City of Hamilton

PUBLIC WORKS COMMITTEE REVISED

Meeting #: 21-016
Date: November 1, 2021
Time: 1:30 p.m.
Location: Due to the COVID-19 and the Closure of City Hall (CC)

8.1.	Hamilton Water Leak Detection Program (PW21063) (City Wide)	82
8.2.	Update to Hamilton's Solid Waste Collection Design Guidelines for Developments (PW21061) (City Wide)	107

2 500 JAMES ST N - PROPOSED HAMMERHEAD IMPACTS
1:200

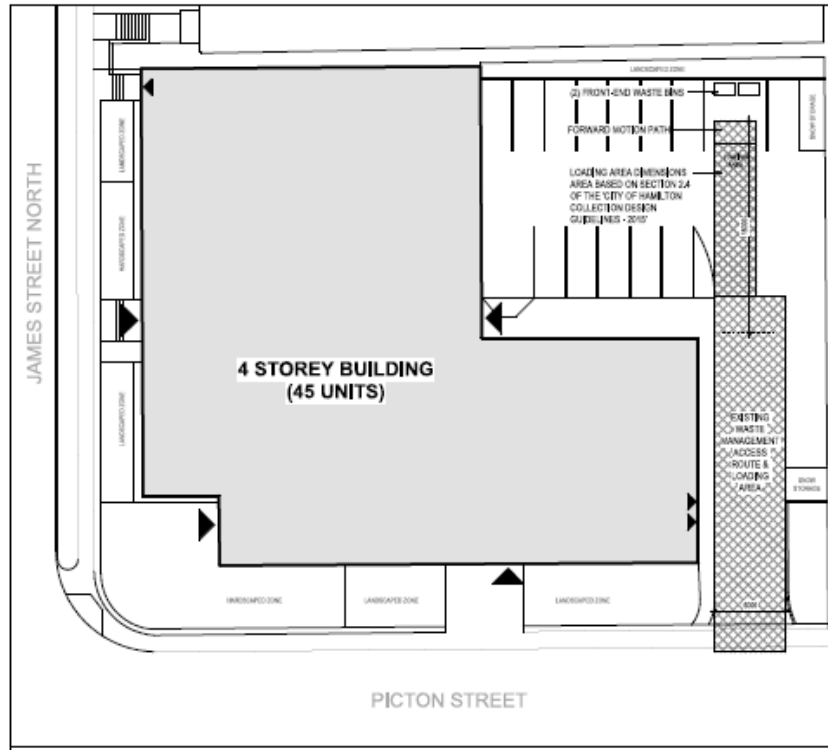
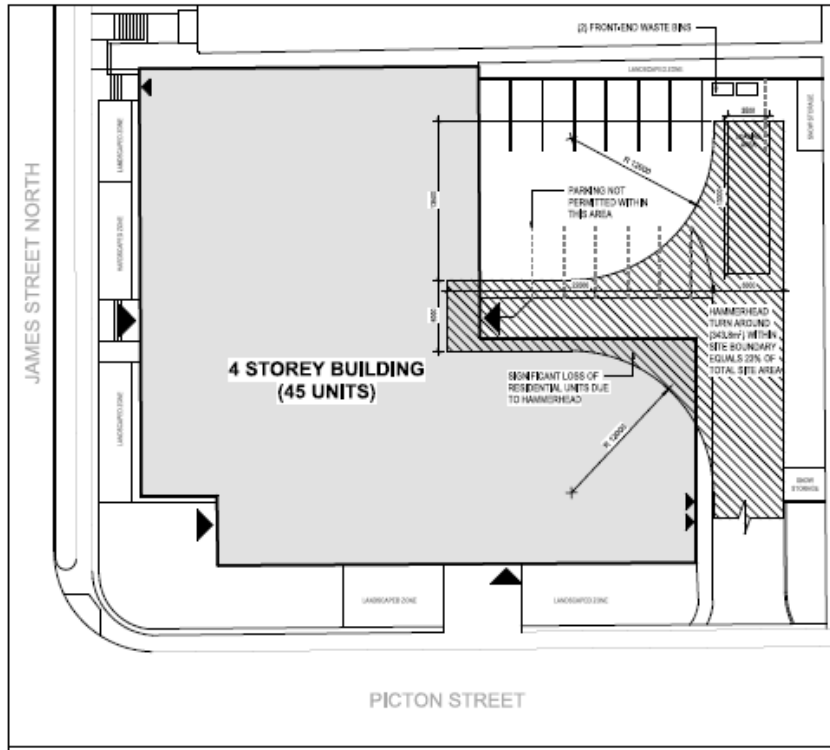
- SIGNIFICANT LOSS OF PARKING DUE TO HAMMERHEAD SPACE REQUIREMENTS
- REDUCTION OF BUILDING AREA AND UNITS DUE TO HAMMERHEAD SPACE REQUIREMENTS
- GOALS FOR INTENSIFICATION WOULD BE REDUCED DUE TO PROPOSED HAMMERHEAD REQUIREMENTS

TOTAL LOSSES:

45 UNITS IS REDUCED TO 41 UNITS BASED ON BUILDING AREA CLEAR OF HAMMERHEAD

45 UNITS - 4 UNITS - 14 UNITS = 27 UNITS TOTAL

2 1430 MAIN STREET - PROPOSED HAMMERHEAD IMPACTS
1:100

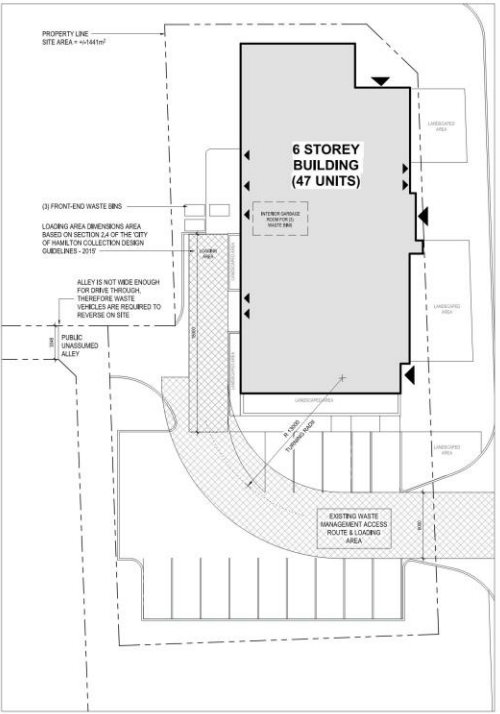
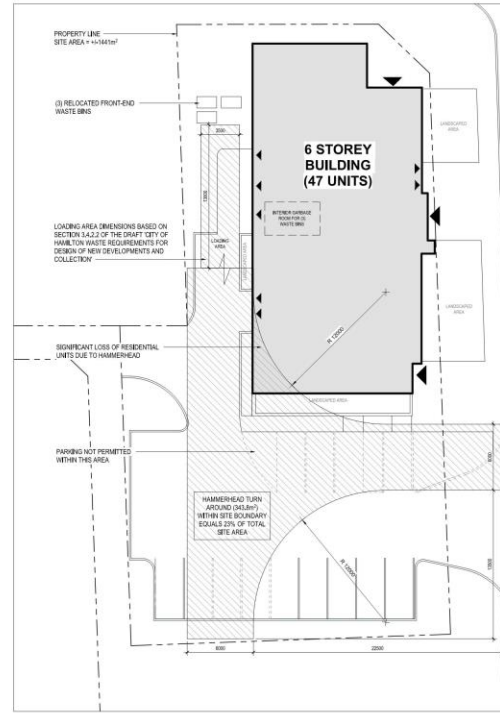
- SIGNIFICANT LOSS OF PARKING DUE TO HAMMERHEAD SPACE REQUIREMENTS (7 SPACES LOST)
- REDUCTION OF BUILDING AREA AND RESIDENTIAL UNITS DUE TO HAMMERHEAD SPACE REQUIREMENTS (MIN. 6 UNITS LOST)
- LOADING AREA IMPEDES EXITING AND EGRESS AT THE REAR OF THE BUILDING
- GOALS FOR INTENSIFICATION WOULD BE REDUCED DUE TO PROPOSED HAMMERHEAD REQUIREMENTS

TOTAL LOSSES:

47 UNITS IS REDUCED BY 6 TO 41 UNITS BASED ON BUILDING AREA CLEAR OF HAMMERHEAD

47 UNITS - 6 UNITS - 14 UNITS = 27 UNITS TOTAL

2 500 JAMES ST N - PROPOSED HAMMERHEAD IMPACTS

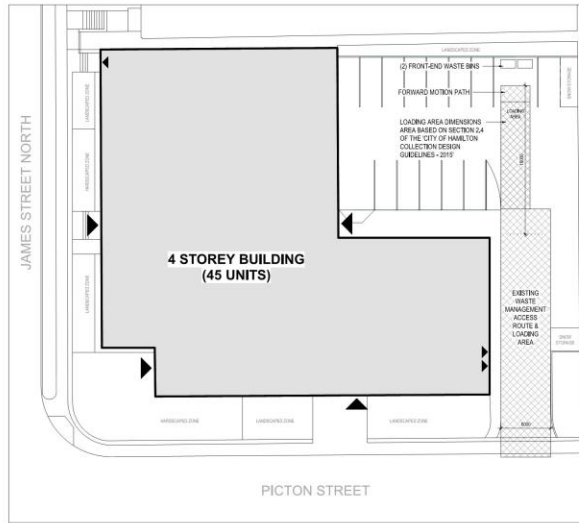
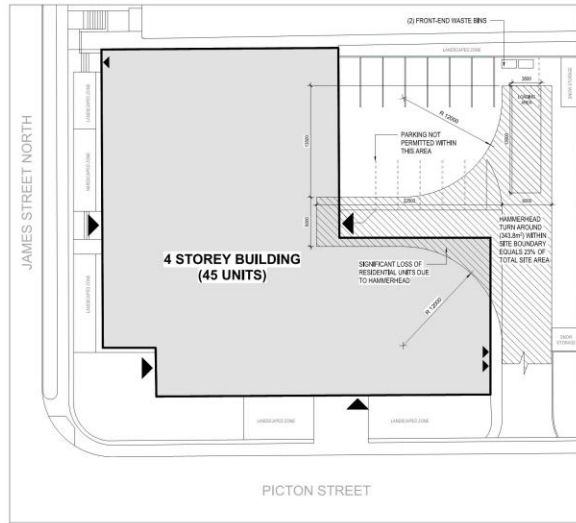
- SIGNIFICANT LOSS OF PARKING DUE TO HAMMERHEAD SPACE REQUIREMENTS
- REDUCTION OF BUILDING AREA AND UNITS DUE TO HAMMERHEAD SPACE REQUIREMENTS
- GOALS FOR INTENSIFICATION WOULD BE REDUCED DUE TO PROPOSED HAMMERHEAD REQUIREMENTS

TOTAL LOSSES:

45 UNITS IS REDUCED TO 41 UNITS BASED ON BUILDING AREA CLEAR OF HAMMERHEAD

2 29 HARRIET - PROPOSED HAMMERHEAD IMPACTS
1:100

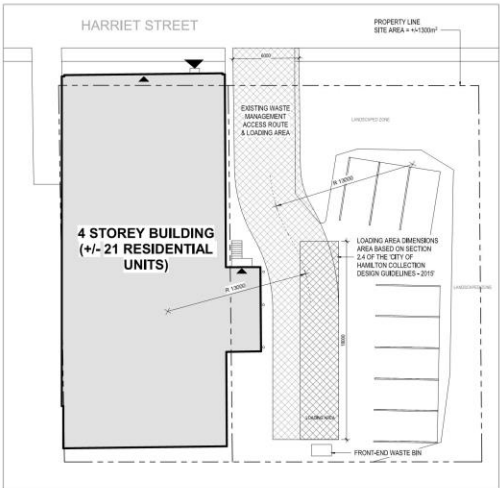
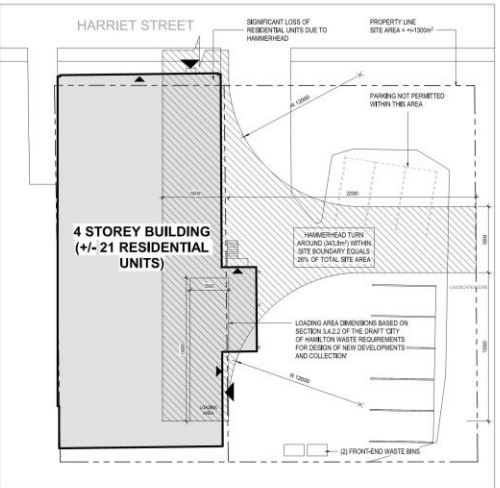
SITE RESULTS DUE TO PROPOSED DRAFT HAMMERHEAD

- THE CURRENT PARKING CONSTRAINTS WOULD ENCOUNTER SIGNIFICANT LOSS OF PARKING CAPACITY DUE TO HAMMERHEAD SPACE REQUIREMENTS
- REDUCTION OF BUILDING AREA AND UNITS DUE TO HAMMERHEAD SPACE REQUIREMENTS (12 UNITS LOST)
- GOALS FOR INTENSIFICATION WOULD BE REDUCED DUE TO PROPOSED HAMMERHEAD REQUIREMENTS

TOTAL LOSSES:

8 EXISTING PARKING SPACES IS REDUCED TO 5

2 92 JOHN STREET - PROPOSED HAMMERHEAD IMPACTS
1:200

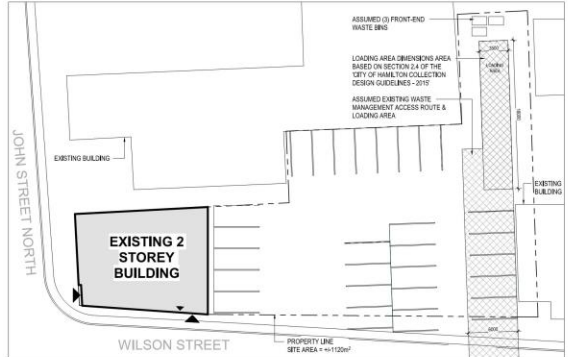
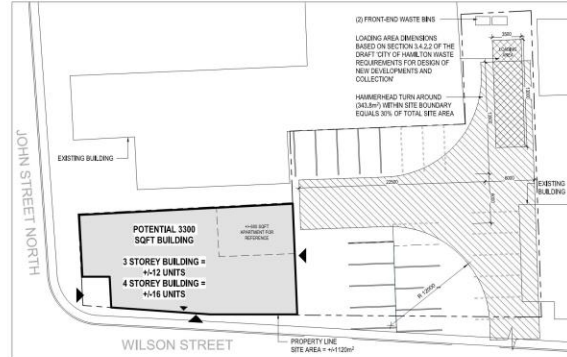
SITE RESULTS DUE TO PROPOSED DRAFT HAMMERHEAD

- SIGNIFICANT LOSS OF PARKING DUE TO HAMMERHEAD SPACE REQUIREMENTS AND INCREASED BUILDING FOOTPRINT TO ALIGN WITH GOALS OF INTENSIFICATION (13 SPACES LOST)
- REDUCTION OF BUILDABLE AREA AND RESIDENTIAL UNIT ALLOWANCE DUE TO LIMITED PARKING CAPACITY
- ADDITIONAL STOREYS BASED ON ZONING HEIGHT LIMITS WOULD MEAN THE BUILDING FALLS INTO 'LARGE MULT-RESIDENTIAL' GARBAGE REQUIREMENTS AND WOULD REQUIRE MORE SPACE FOR GARBAGE
- EXISTING NEIGHBOURING BUILDINGS WOULD REQUIRE DEMOLITION
- GOALS FOR INTENSIFICATION WOULD BE REDUCED DUE TO PROPOSED HAMMERHEAD REQUIREMENTS

TOTAL LOSSES:

INCREASES TO THE OVERALL BUILDING HEIGHT WOULD ALSO INCREASE THE PARKING AND GARBAGE REQUIREMENTS

1 SITE PLAN - Isabella (Ottawa)
1:100

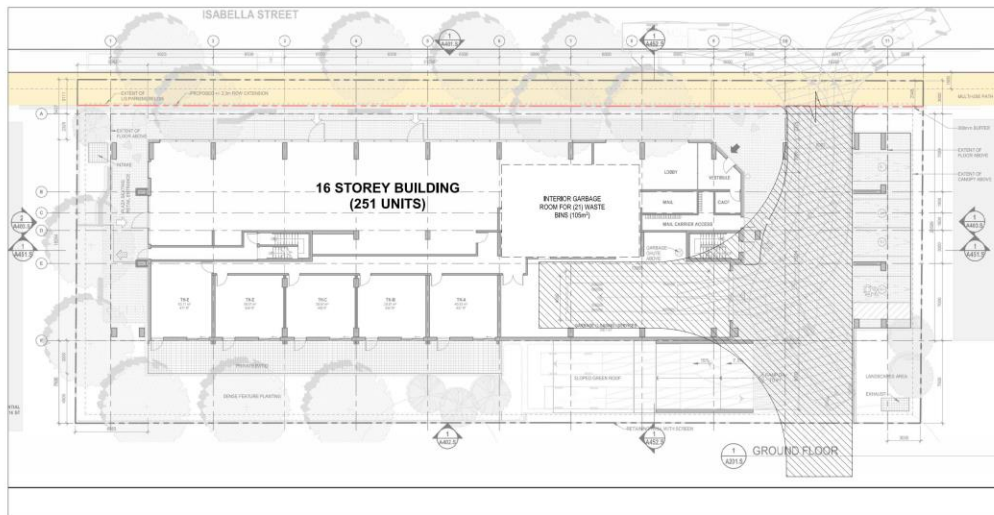
SITE SUMMARY - BASED ON THE DRAFT CITY OF HAMILTON WASTE REQUIREMENTS FOR DESIGN OF NEW DEVELOPMENTS AND COLLECTION

- 16 STOREYS + LARGE RESIDENTIAL
- GARBAGE, RECYCLING AND GREEN CARTS
- +12 GARBAGE CONTAINERS (NON-COMPACTED)
- 6 (+7) GARBAGE CONTAINERS (COMPACTED)
- 12 RECYCLING ORGANIC CONTAINERS
- 3 ORGANIC FRONT END CONTAINERS

- LOSS OF UNITS AND OVERALL BUILDABLE AREA DUE TO REQUIRED HAMMERHEAD
- LOSS OF UNITS DUE TO SPACE REQUIREMENTS FOR INTERIOR GARBAGE STORAGE
- PROJECT WOULD REQUIRE SIGNIFICANT REDESIGN IF PLANNED FOR THE CITY OF HAMILTON
